Access Compliance Report Public Rights-of-Way (Pedestrian Signals)

Main Street: **BEACH_BLV** Cross Street: **BOLSA_AVE** Location: **NE**

ADA ID: **SGRK210929151700** Signal Type: **One Push Button-APS** Overall Compliance: **No** Severity Scores: **BTN 1: 25 BTN 2: N/A No BTN: N/A**

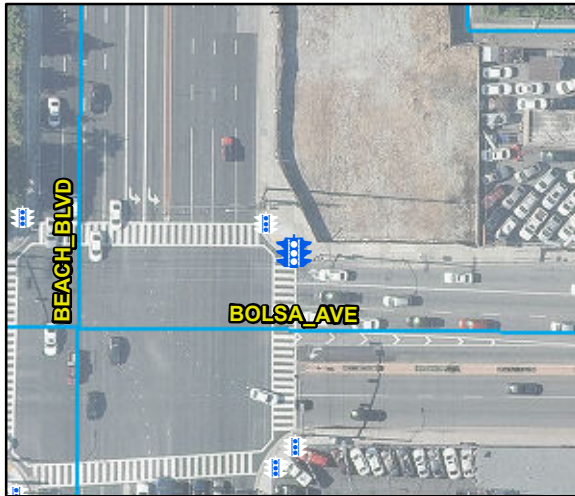
Possible Solutions: Remove and Replace Clear Space.

OC Std/PROW: **R404.2, R404.3**
